## EXAMINATION of the SEDGEFIELD PLAN

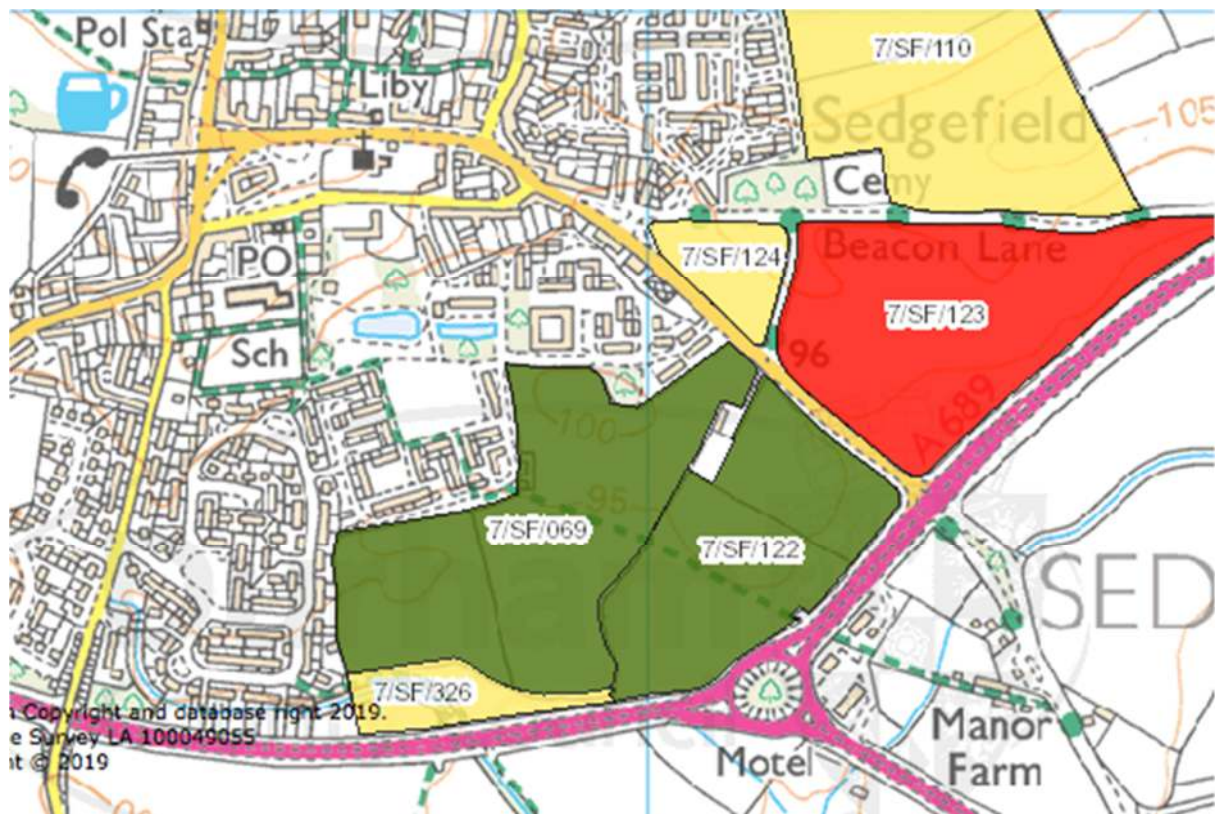
Q2. I note the built-up area boundary is based on planning permission commitments. However the SHLAA 2019 and its associated maps show site 7/SF/122, land at Stockton Road, granted planning permission on appeal, as extending further than that indicated by the proposed built-up area boundary. The Plan built-up area boundary does not extend as far east as that shown on the SHLAA maps. Furthermore, I cannot trace an allowed appeal relating to Stockton Road on the Council's web site search. I can only discover an appeal, which was withdrawn. Please can either the Town Council or the Council clarify the reason there is a difference in these boundaries and that permission has been granted on the land at Stockton Road and if so the extent of the boundary?

I attach screen shots of the relevant map and built-up area boundary shown in the Plan.

- *The proposed built-up area boundary is reflective of existing permissions.*
- *Permission was refused for a hybrid proposal (ref: DM/15/03808/OUT) on the South of Eden Drive site for a total of 300 units (220 in outline and full permission for 80).*

- *This was subsequently allowed at appeal - reference: APP/X1355/W/16/3150609*
- *Reserved matters (ref: DM/17/01322/RM) was approved for 197 on the larger portion of the site (SHLAA ref 7/SF/ 069).*

- *Both schemes have started on site.*
- *SHLAA site 7/SF/122 has not been split up to reflect the permission on part of that site, and therefore covers the paddock to the east which is currently the subject of a separate planning application (pending consideration for 60 units – ref: DM/18/00536/FPA).*

- *The Town Council propose a built-up area boundary which effectively excludes the eastern portion of site 7/SF/122 which is currently under consideration, as the Town Council consider that sufficient new housing is already in place.*

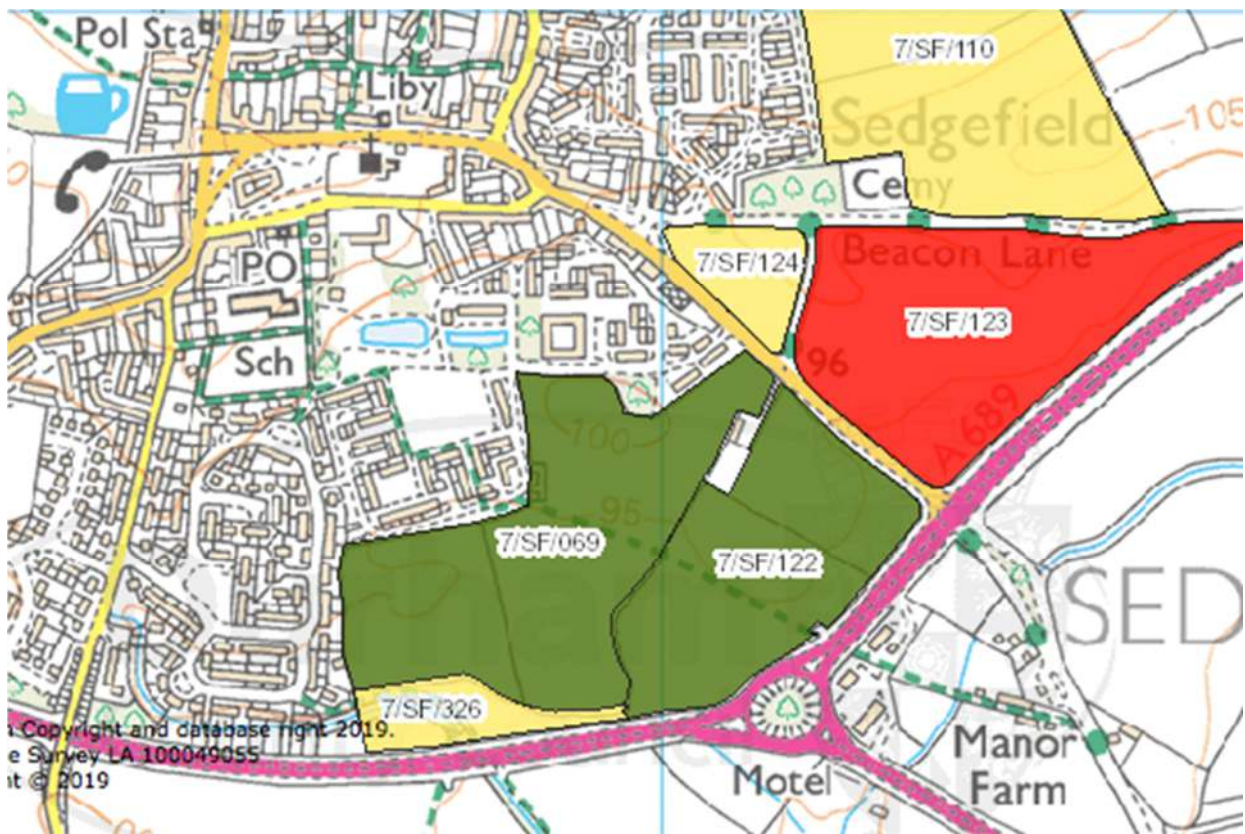
Q3. The Policy justification on page 23 refers to a field “at the entrance to the community” where there is a need to protect the ridge and furrow archaeology and views of the church. Where is this land? If so, is it the land that I refer to above that has been excluded from the built-up area boundary?

*The field in question is referred to localised as the ‘three-cornered field’ and is identified as the yellow triangle labelled 7/SF/124 below, just outside the built-up area boundary (see map below).*
